**BELL BEND NUCLEAR POWER PLANT  
RESPONSE TO RAIS ENV-28 AND ENV-29  
BNP-2014-022      Docket No. 52-039**

This letter provides the PPL Bell Bend, LLC (PPL) responses to the Requests for Additional Information (RAI) Nos. ENV-28 (Reference 1) and ENV-29 (Reference 2). The RAIs address information contained in the Bell Bend Nuclear Power Plant (BBNPP) Combined License Application (COLA) Part 3, Environmental Report (ER).

The Enclosure provides PPL's responses to RAI ENV-28, Questions: AE-7314; AE-7324; ALT-7318; HY-7332; NFP-7334; and, RAI ENV-29, Questions HY-7329 and TE-7338

**Figure 1 - Walker Run Bridge, top view**

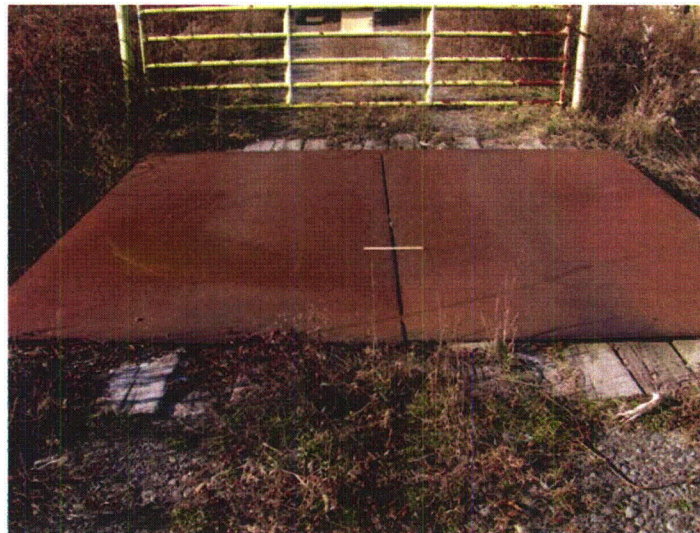
ESRP Section 4.3.2 directs the staff's description, quantification, and assessment of the impacts of construction of the proposed facilities on the aquatic ecosystem. PADEP Water Obstruction and Encroachment Permit, E40-720 (ML13161A023) identifies bridge removal as an impact associated with Joint Permit Application (JPA) Impacts A (Walker Run) and B (Unnamed Tributary 1). The JPA and ER Rev 4 do not describe the bridge removal process and the associated potential impacts. Describe the bridge removal process associated with JPA Impacts A (Walker Run) and B (Unnamed Tributary 1). Characterize the potential impacts to aquatic resources from the bridge removal and describe any steps that would be taken to minimize those impacts.

The bridge over Walker Run consists of three sections (refer to attached Figures 1 through 3). The lower section is a 10-foot long, 12-foot wide concrete arch spanning Walker Run. The top flat part of the arch is covered by a middle section consisting of 15 railroad ties laying side-by-side. Each tie is 13 feet in length, 9 inches wide and 7 inches in height. The two end sections of each tie are embedded in the top part of the stream bank. The railroad ties are covered by two 1/2-inch steel plates tack welded together at the center seam. Each plate measures 10 feet in length and is 6 feet wide. The top of the bridge measures approximately 10 feet in length and 12 feet wide. There are three vertical straps welded to each plate's side to prevent the top plate from shifting from side-to-side. The top of the bridge is about 5 feet from the bottom of the stream at low level. The bridge will be removed by a machine such as a back hoe.

The removal of the Walker Run Bridge will occur during construction of the Walker Run mitigation project. Walker Run will remain in the existing stream channel while the restored channel is being constructed under dry conditions. Following new channel construction and the installation of appropriate stabilization measures, as described in the Walker Run Mitigation Plans dated August 12, 2011 included in the Walker Run Design Report Rev 0 (JPA Rev.1 Mitigation Section), the flow will be directed from the existing channel into the new, restored channel. At this point the bridge will be removed. Since the channel will already be abandoned at the time of the bridge removal, there will not be any impacts to the watercourse resulting from bridge removal.

**Exploded view of ER Figure 2.3-93 Groundwater Well Locations within a 5-Mile (8-km) Radius**

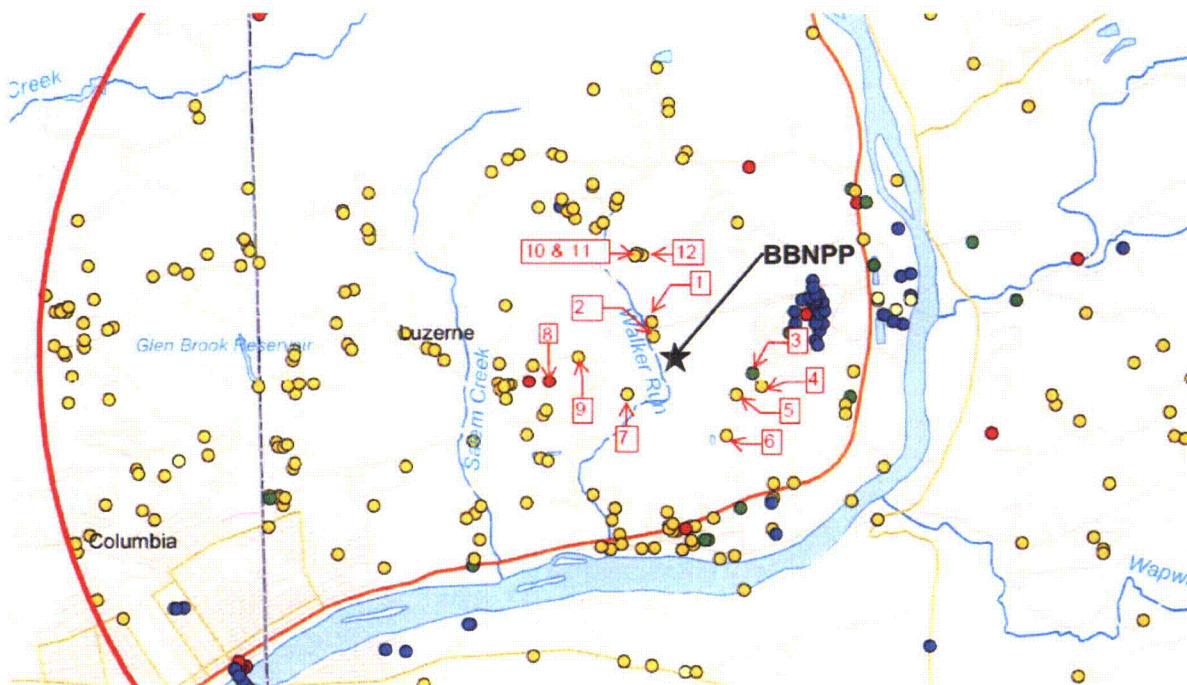
ESRP Section 2.3.2 directs the staff's description of surface water and groundwater uses and users that could be affected by the proposed project. For groundwater uses, this description includes locations and depths of the wells, identification of the aquifers from which water is withdrawn, and the average withdrawal rates. For surface water, non-consumptive water uses must be included in the description. The ER does not adequately describe water uses for nearby wells and surface water bodies. Provide groundwater use information for the wells located within approximately one mile of the BBNPP site, as shown in ER Figure 2.3-93, including the domestic well shown located near the pond on the property to the south of the site. Identify any non-consumptive uses for the surface water bodies located on the property to the south of the BBNPP site.

There are twelve (12) wells located within an approximate 1-mile radius from the Bell Bend Nuclear Power Plant (BBNPP) reactor centerline illustrated on Figure 2.3-93, "Groundwater Well Locations within a 5-Mile (8-km) Radius" of the BBNPP Combined License Application (COLA) Part 3, "Environmental Report" (ER). These wells are identified on the attached exploded view of ER Figure 2.3-93, below. Information for these wells are in the table, "Well Information within Approximately 1-Mile Radius," below.

ER Section 2.3.1.2, "Groundwater Resources" discusses the three aquifers located at the BBNPP site and ER Figure 2.3-36, "Thickness Map of the Glacial Overburden Aquifer" provides a thickness profile of the glacial outwash thickness. Based on this information, the two shallow wells (#3 and #5) are most likely in the Glacial Outwash Aquifer. ER Section 2.3.1.2.3.1, "Site

Hydrogeology” places the division between the Shallow Bedrock and Deep Bedrock aquifers at approximately 175 feet. Therefore, all the other wells, except for Well # 8, are most likely located in the Shallow Bedrock aquifer. Well #8, at a depth of 380 feet, is most likely located in the Deep Bedrock aquifer.

Annotated FSAR Figure 2.4-47, "Surficial Deposits in the BBNPP Site and Vicinity"

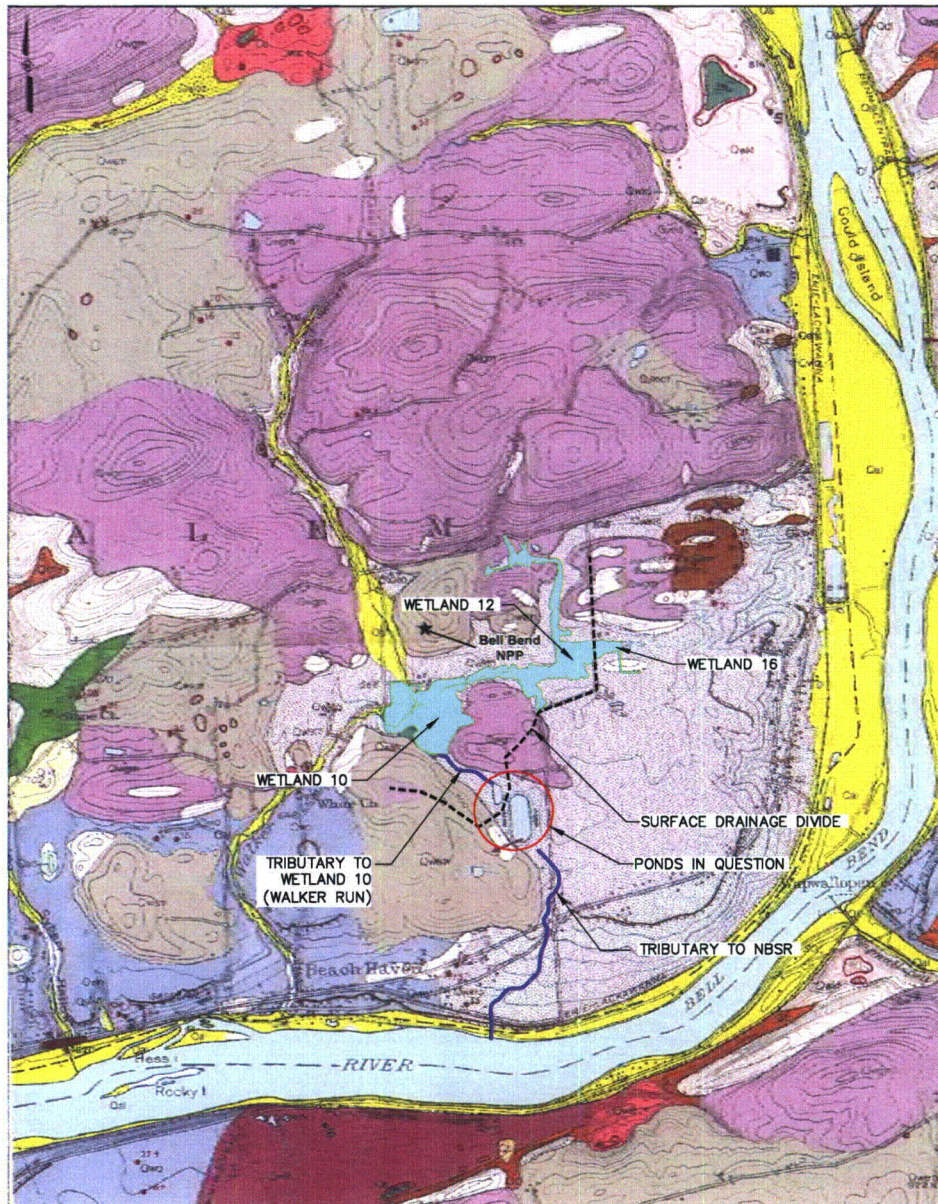
ESRP Section 2.3.1 directs the staff's description of the hydrology of the proposed plant site and the surrounding area that could be affected by construction activities and plant operation. This description includes interactions between surface water and groundwater. The ER does not adequately describe the water resources located on the property to the south of the BBNPP site. Identify the source(s) of water for the surface water bodies shown in ER Figure 2.3-3 on the property to the south of the BBNPP site. These features include the oval-shaped pond and the adjacent, smaller pond to the northwest, the stream between this smaller pond and the wetlands near the confluence of Unnamed Tributary 1 and Walker Run, and Unnamed Tributary 3. Describe the interactions between these surface water bodies and between these surface water bodies and the groundwater.

These surface water bodies shown in the Bell Bend Nuclear Power Plant (BBNPP) Combined License Application (COLA) Part 3, Environmental Report (ER) Figure 2.3-3 "Walker Run Watershed" occur along the surface drainage divide. The location of the ponds Wetlands 12 and 16; the surface drainage divide; and other surface drainage features, are shown on the attached annotated Final Safety Analysis Report (FSAR) Figure 2.4-47, "Surficial Deposits in the BBNPP Site and Vicinity" illustrating the surficial geologic formations in the vicinity of the BBNPP site. The oval pond is in the center of an old motorcycle racetrack, so the pond configuration and surface hydrology has been historically manipulated to provide drainage for the racetrack into the pond. The oval pond drains to an unnamed tributary to the North Branch of the Susquehanna River, originating from the southeast corner of the pond and flowing south to the river. The smaller pond drains to a stream/wetland system flowing northwest to Wetland 10 on the Bell Bend site, and ultimately to Walker Run. Despite the presence of the surface drainage divide, it is highly likely that there is a subsurface groundwater connection between the two ponds. The ponds are situated in the same glacial overburden deposits as Wetlands 12 and 16, which are located on the Bell Bend site farther north adjacent to Confers Lane. Confers Lane has been identified as the surface drainage divide between these two wetlands, but a subsurface groundwater connection has also been determined. The oval pond and smaller pond in question are in a similar landscape position and in the same geologic formation as Wetlands 12 and 16, and appear to have a similar groundwater connection. There is some visual evidence from aerial photographs that there may be a pipe connection between the two ponds from the northwest corner of the oval pond to eastern side of the smaller pond, but this has not been field verified. Note that this evaluation is based on available aerial imagery, geologic mapping, and a general understanding of the local geologic and hydrologic conditions and patterns. Field investigations have not been conducted on this site, as it is outside of Bell Bend or other PPL-owned property.
